**SURFACE WATER AND SEDIMENT ADDENDUM TO THE  
PHASE I FIELD SAMPLING PLAN FOR  
GROUNDWATER, SURFACE WATER, AND SEDIMENT  
SANTA SUSANA FIELD LABORATORY SITE  
AREA IV RADIOLOGICAL STUDY**

**TO:** Nicole Moutoux, EPA Region 9 RPM  
**FROM:** Terry Stewart Williford, HGL Geologist  
**THROUGH:** L. Steven Vaughn, HGL Project Manager  
**CC:** Mary Aycock, EPA Region 9 RPM  
Craig Cooper, EPA Region 9  
Gregg Dempsey, Technical Advisor  
**DATE:** December 6, 2010  
**SUBJECT:** FSP Addendum for Surface Water and Sediment  
**CONTRACT NO:** EP-S7-05-05  
**TASK ORDER NO:** 0038

The purpose of this addendum is to document the changes made to the surface water and sediment sampling location maps and completed action items based on the comments recorded at the Technical Breakout Session held on November 18, 2010.

**Figure 1**  
**Surface Water, Seeps, and Drainage**

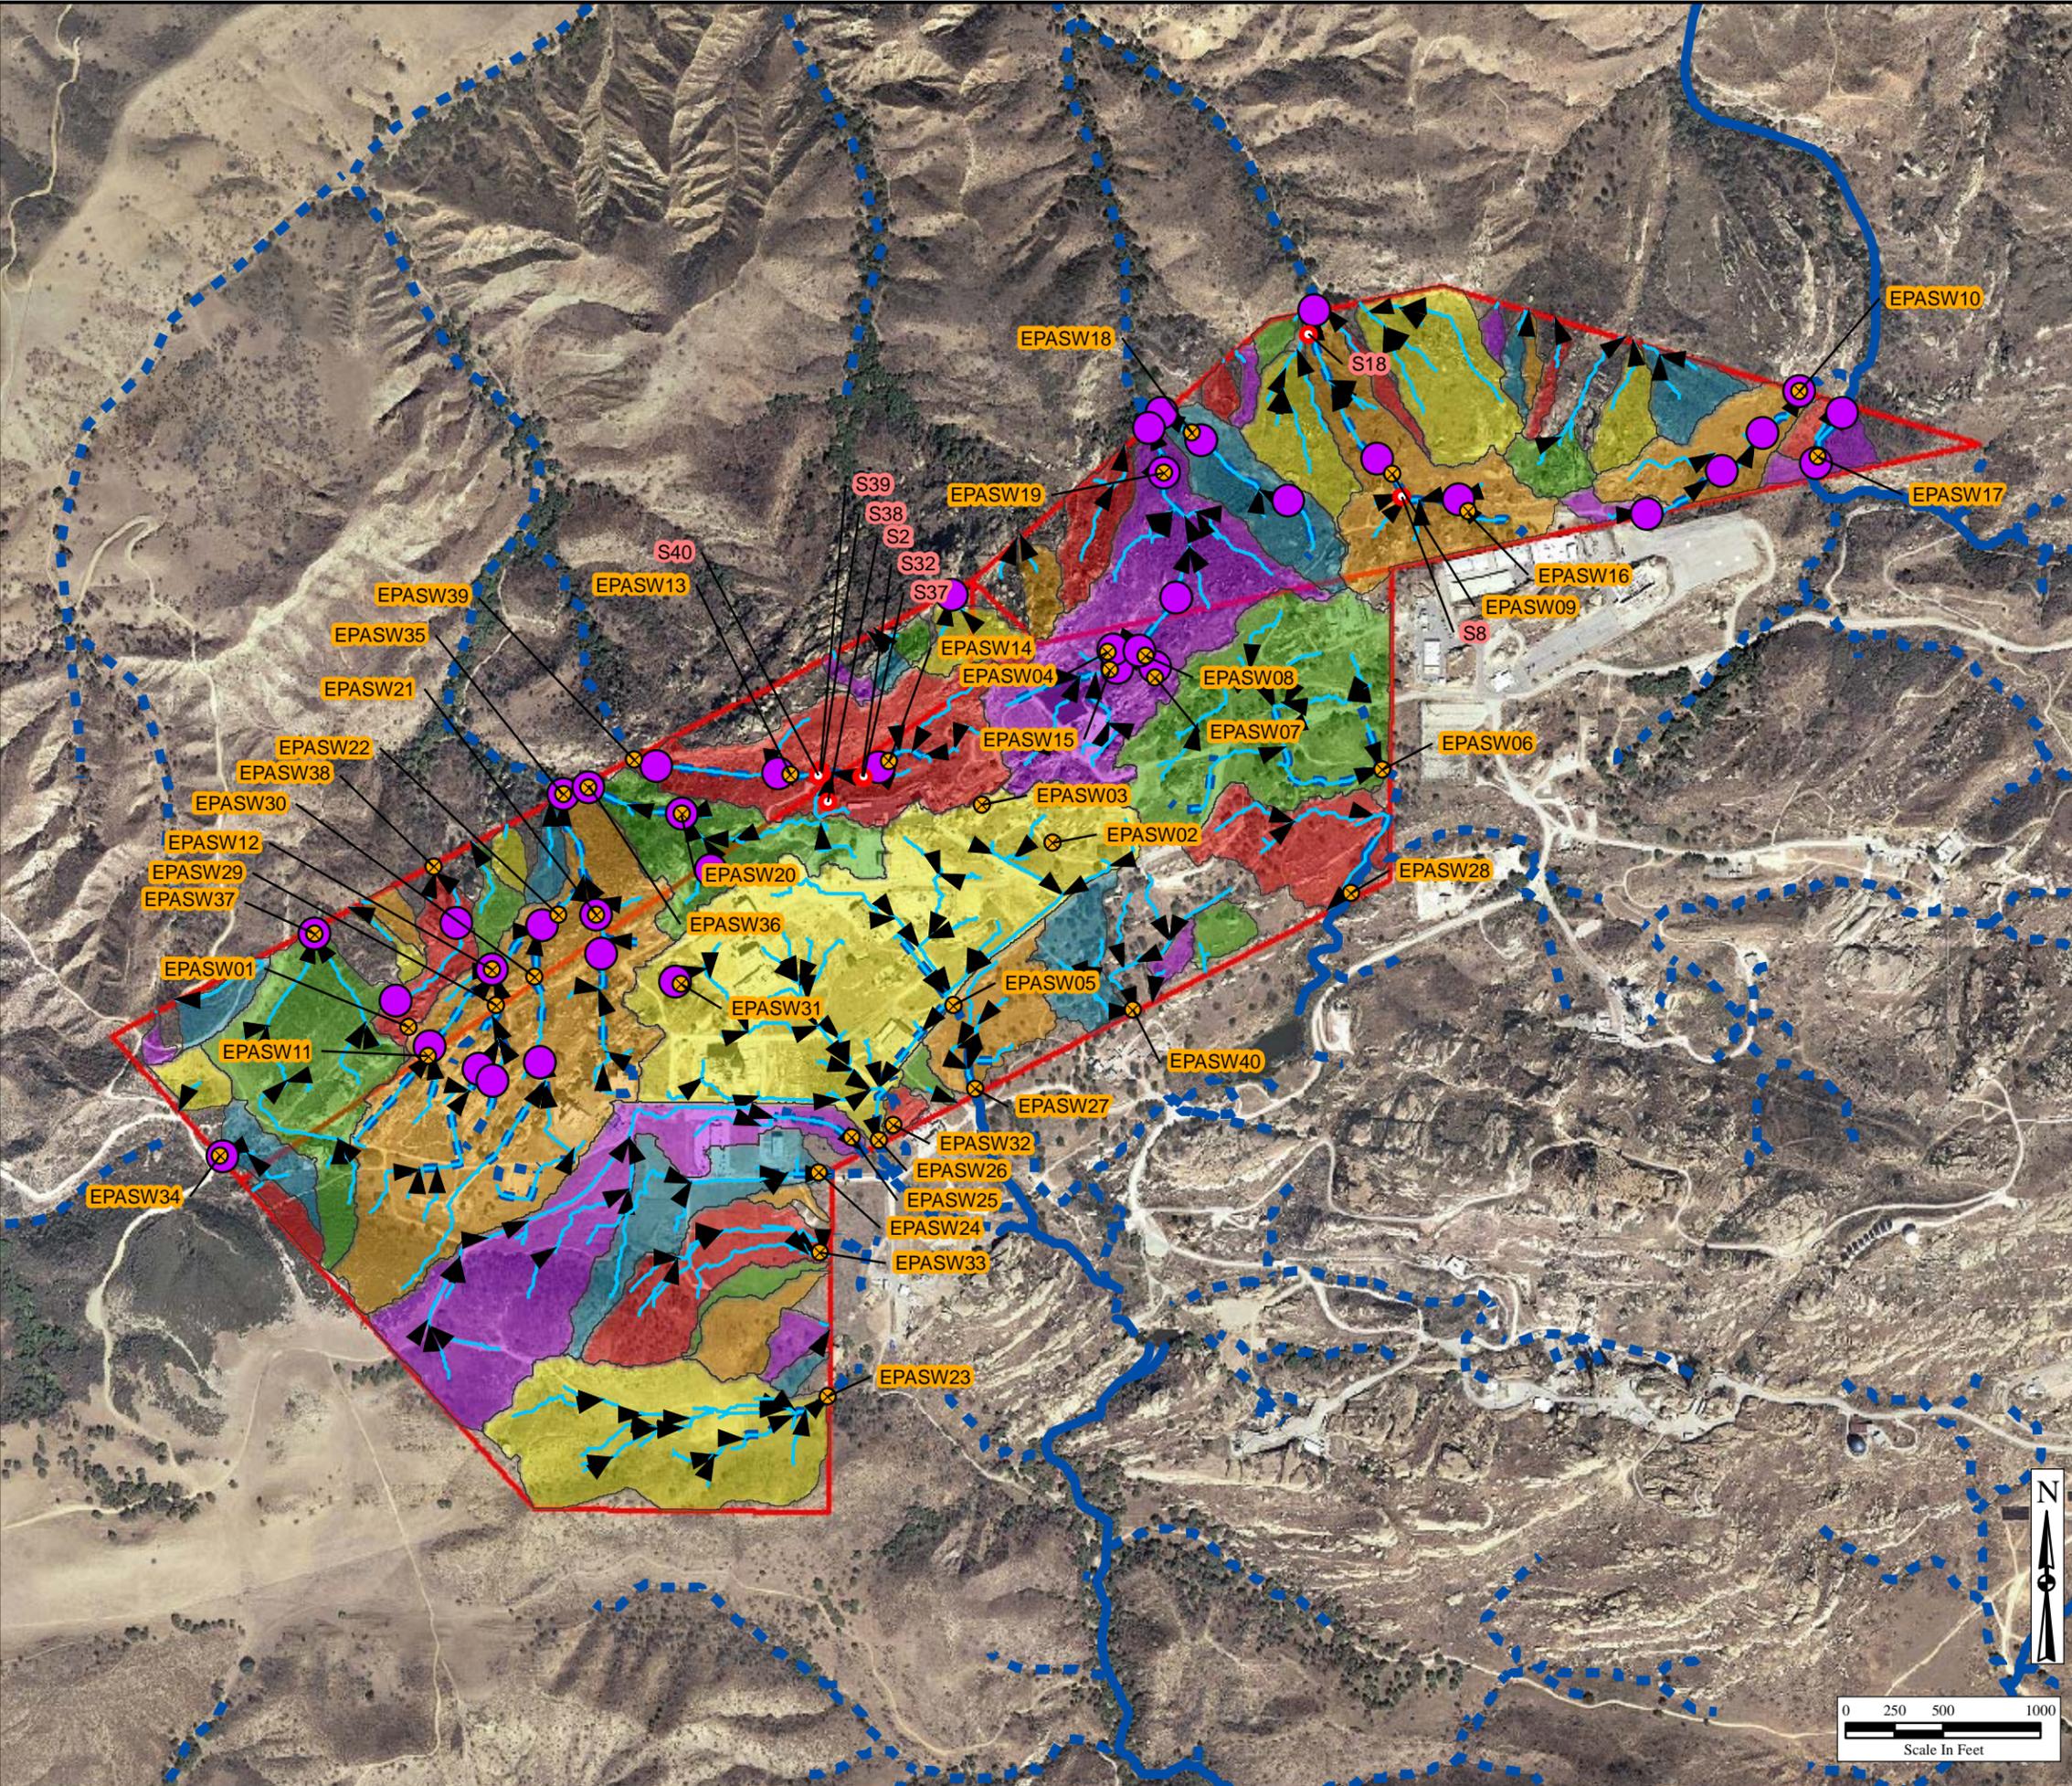
Revisions made to the surface water sampling location map (Figure 1) are as follows:

- EPASW37 – Added to investigate the surface water that may originate from the sodium burn pit area and receives surface run off from the Arness fire road located in the northwest corner of the NBZ.
- EPASW38 – Added to investigate the surface water received from the fire road located in the northwest corner of the NBZ that leads to the RD-33 cluster of wells.
- EPASW39 – Added to focus sampling efforts downgradient of Outfall 3 and the Radiological Materials Disposal Facility.
- EPASW40 – Added to characterize the surface water leaving the Area IV to the southeast.

**Figure 2**  
**Sediment and Drainage**

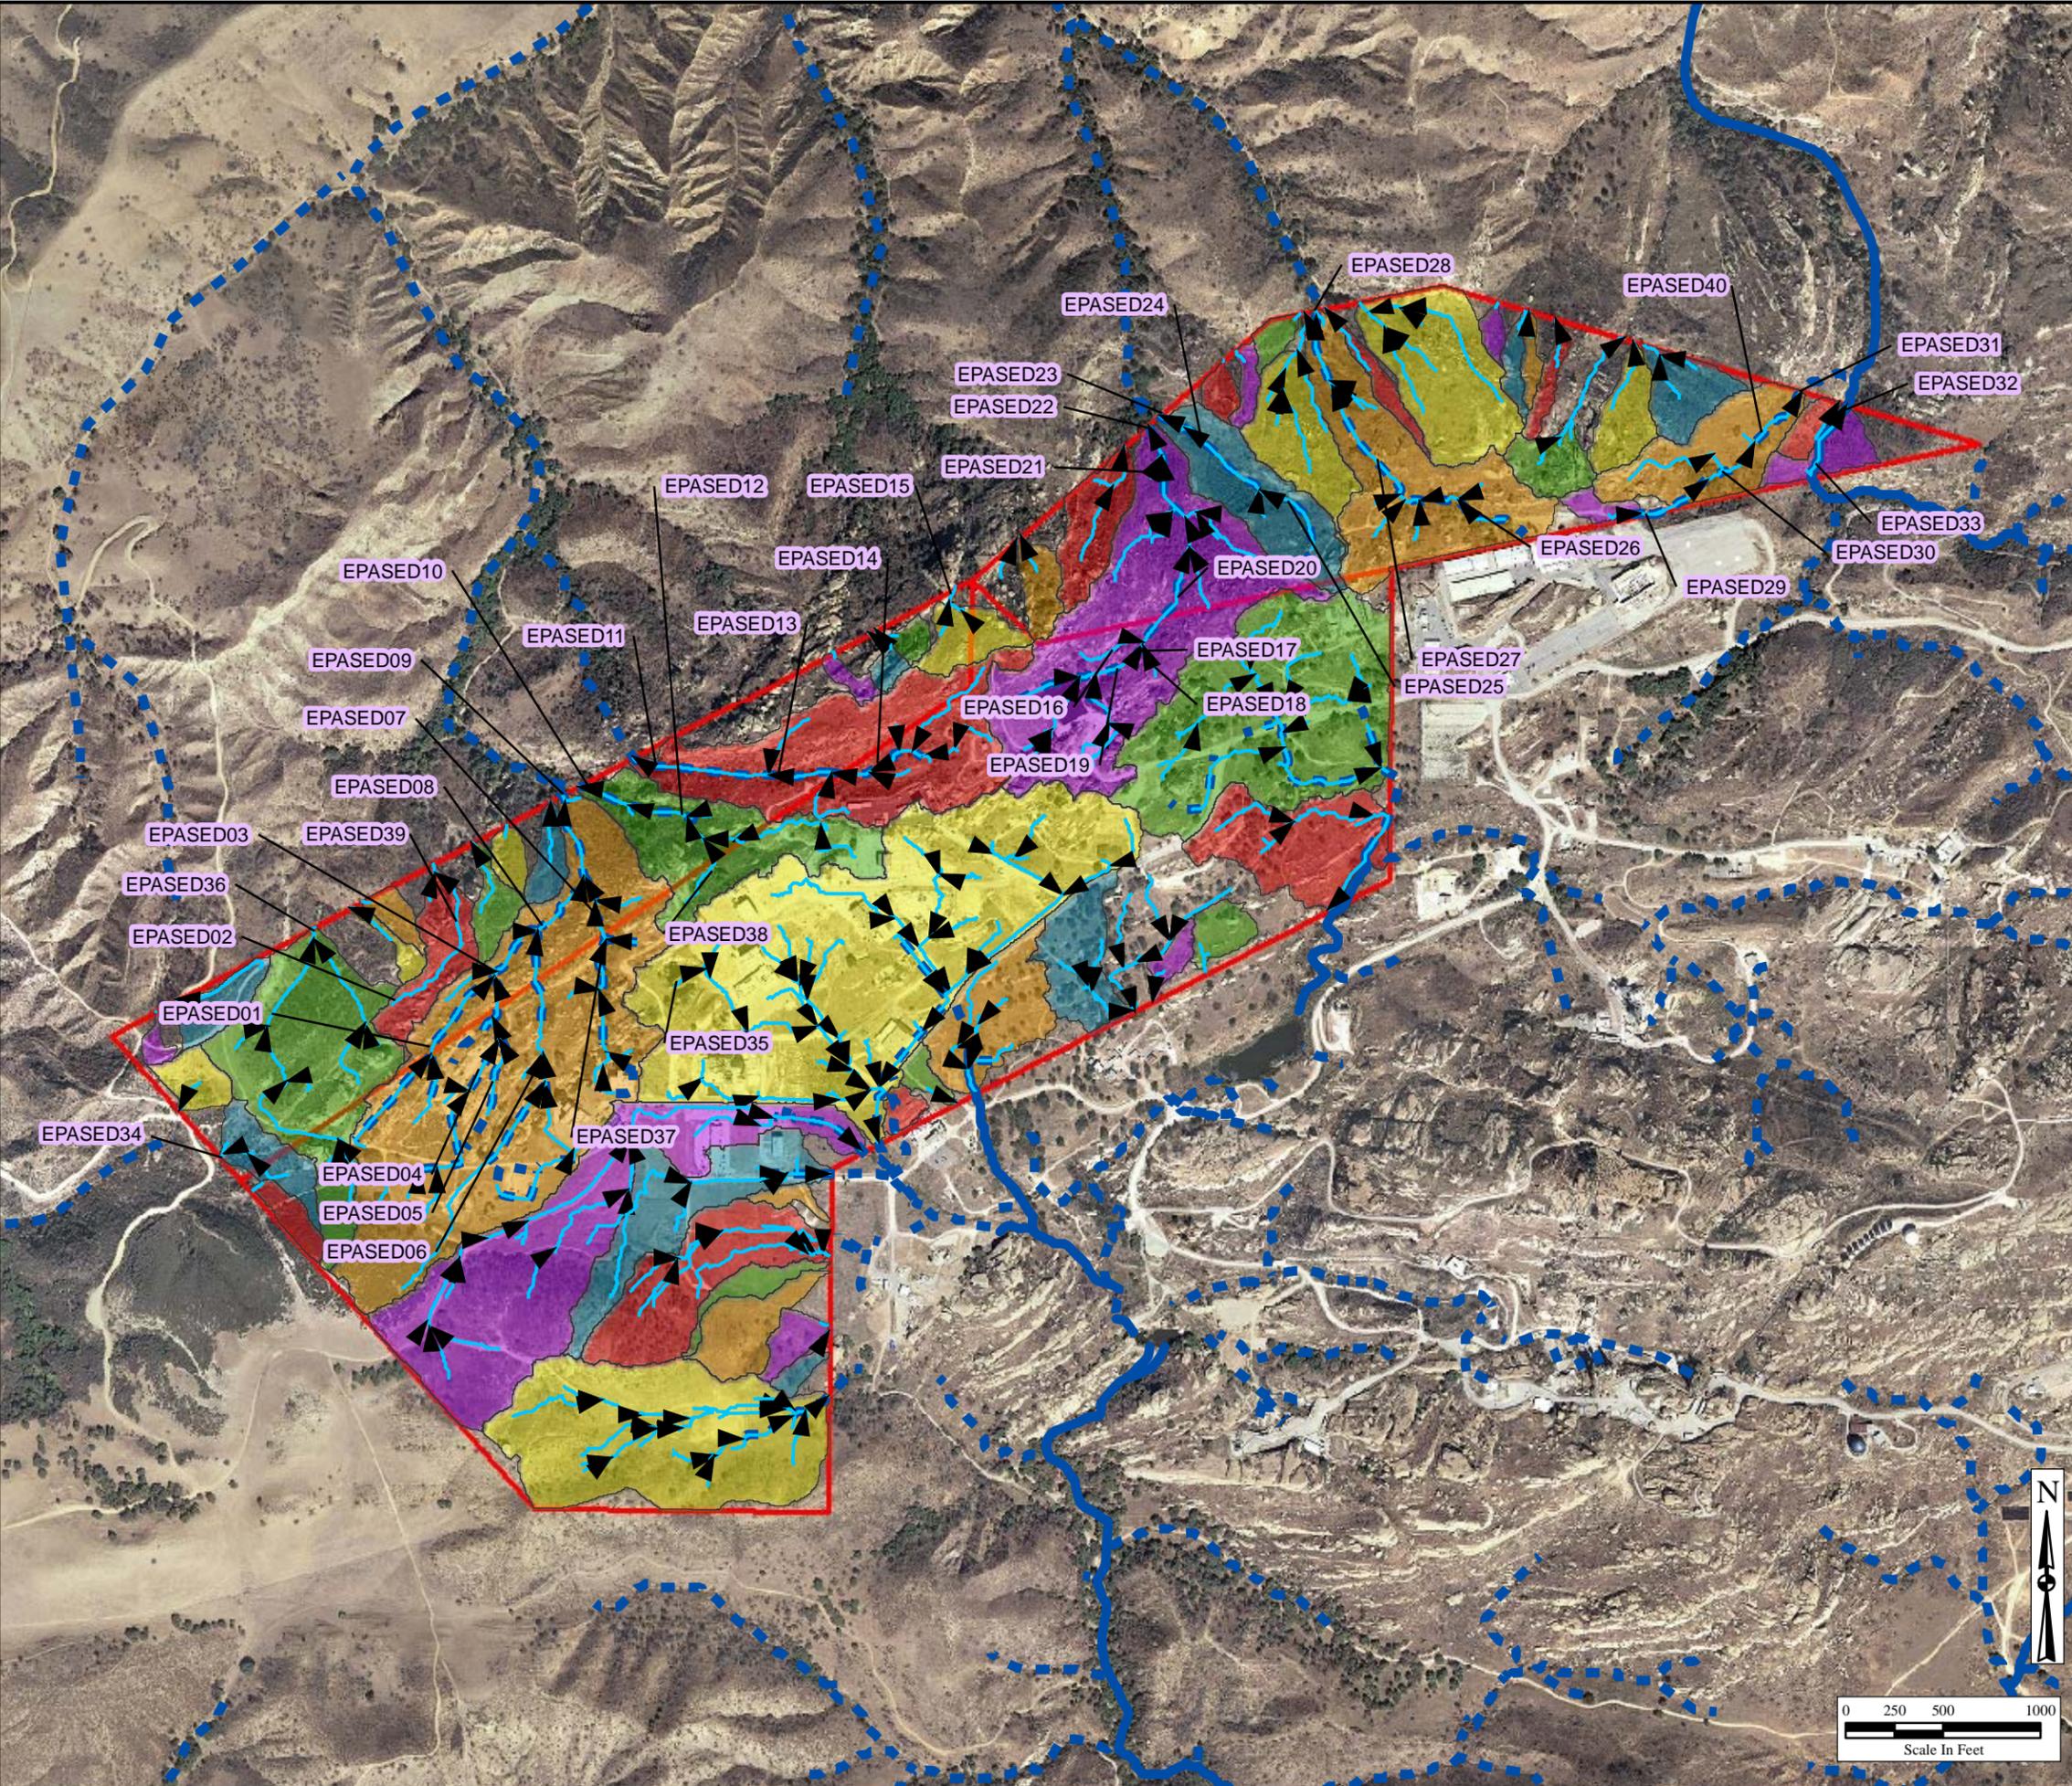
Revisions made to the sediment sampling location map (Figure 2) are as follows:

- EPASED15A (alternate location) – This location was eliminated in order to focus sediment sampling efforts to the areas of primary concern.
- EPASED15 - Relocated in order to focus sediment sampling locations in drainages downgradient of roads that may have been used to facilitate the release of discarded waste.

- EPASED34 - Relocated to be co-located with surface water sample EPASW34. The original location was in the drainage located in the southern portion of Subarea 5B. The drainage will be sampled as part of the Subarea 5B soil sampling program.

- EPASED36 - Added to investigate the sediment that may have originated in the sodium burn pit area or from the Arness fire road located in the northwest corner of the NBZ.

- EPASED37 - Added to characterize sediment that potentially originated from the 56 Landfill located northwest of the Building 56 excavation.
- EPASED38 - Added to characterize sediment transported downgradient from the SNAP area.

- EPASED39 - Added to characterize sediment transported downgradient from roads that may have been used to facilitate the release of discarded waste.
- EPASED40 - Added in an effort to further evaluate the plutonium result reported in the Boeing paper “Plutonium-238 at Brandeis-Bardin” (Boeing, 2008).
